### OVEN – FOOD PROBE SOCKET ON OVC5000 POB

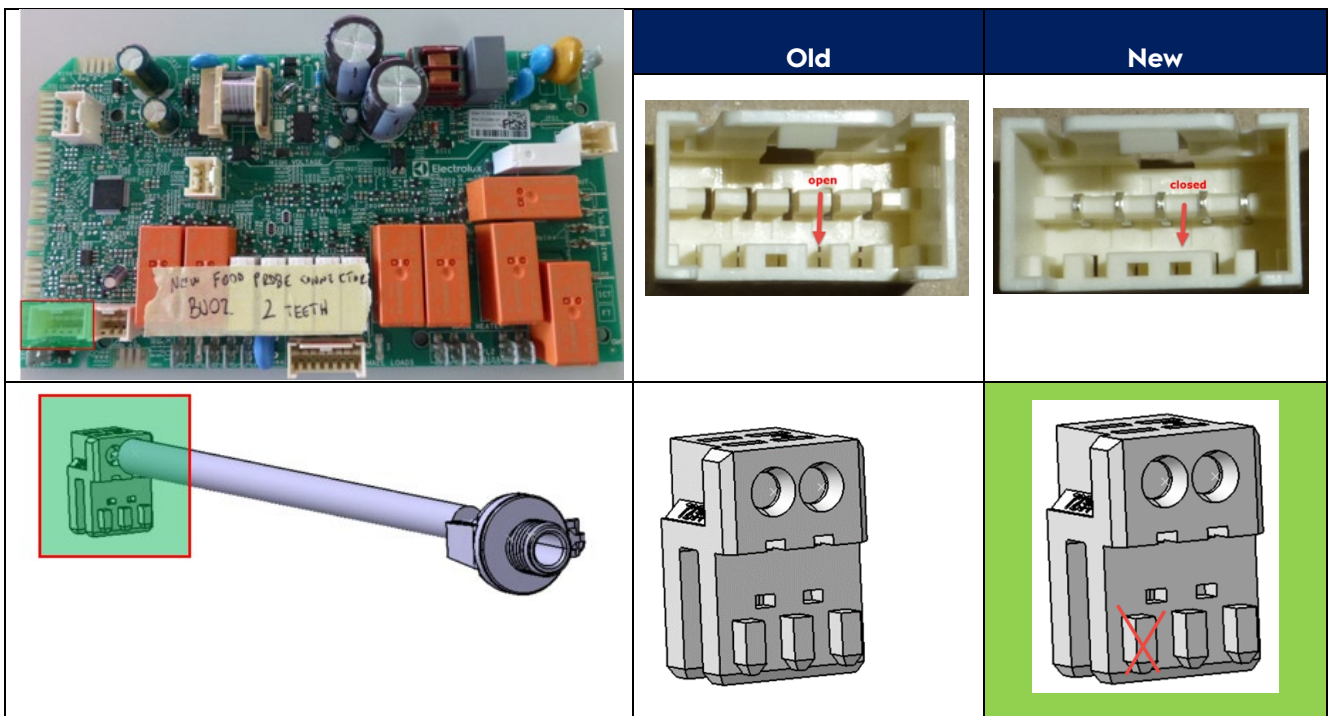
Mechanical Coding of Food Probe socket on OVC5000 has changed from 3-teeth to 2-teeth.

To fit into the 2-teeth housing please cut the **disturbing teeth** by a **cutter**.
